Access Compliance Report

Public Rights-of-Way

(Curb Ramps)

Intersection ID: 31277	Main Street: GARRETT_GRIGG_RD	Cross Street: TIGER_LN	Location: E
ADA ID: 61B30720495C	Ramp Type: PerpDiag	Initial Pass/Fail: Fail	Overall Compliance: No
Codes/Mitigation Info/Possible Solution		Field Measurements/Component Compliance	
Severity Score: 8.75

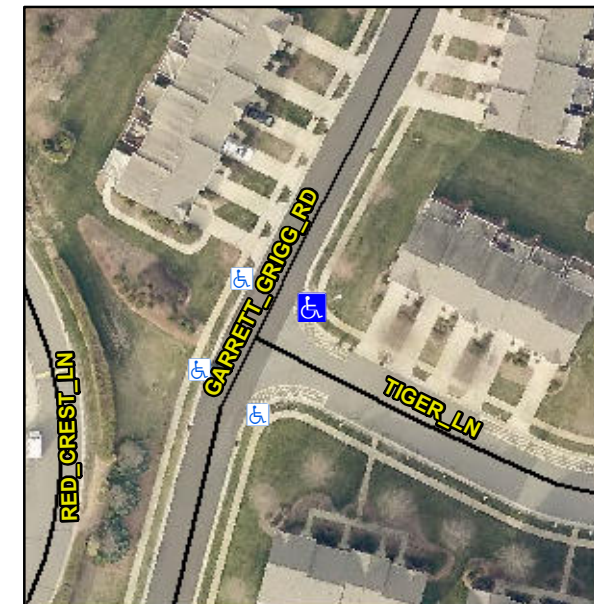
Not Found, R304.5.1

Compliance	Description	Data	Compliance	Description	Data
N/A	Ramp Length (in)	59.0	Yes	Ramp Slope (%)	5.5
No	Ramp Width (in)	39.0	Yes	Ramp XSlope (%)	1.2
N/A	Flare Type LT	N/A	N/A	Flare Type RT	N/A
N/A	Flare Slope LT (%)	N/A	N/A	Flare Slope RT (%)	N/A
N/A	Flare Traversable LT?	N/A	N/A	Flare Traversable RT?	N/A
N/A	Landing Length (in)	N/A	N/A	DWS Provided?	N/A
N/A	Landing Width (in)	N/A	N/A	DWS Contrast?	N/A
N/A	Landing Slope (%)	N/A	N/A	DWS Length (in)	N/A
N/A	Landing X Slope (%)	N/A	N/A	DWS Full Width?	N/A
N/A	Landing Curb? (Y/N)	N/A	N/A	DWS Offset (in)	N/A
N/A	Shared Landing?	N/A			
N/A	Gutter Ponding?	N/A	N/A	Gutter Slope (%)	N/A
N/A	Gutter Lip Ht (in)	N/A	N/A	Gutter X Slope (%)	N/A
N/A	Painted X Walk1?	No	N/A	Painted X Walk2?	No
	X Walk 1 Direction	To NW		X Walk 2 Direction	To SW
N/A	X Walk 1 Width (in)	N/A	N/A	X Walk 2 Width (in)	N/A
	X Walk 1 Slope (%)	4.7		X Walk 2 Slope (%)	4.8
	X Walk 1 X Slope (%)	2.0		X Walk 2 X Slope (%)	0.5

Remove & Replace Curb Ramp With Two New Directional Ramps or Equivalent.
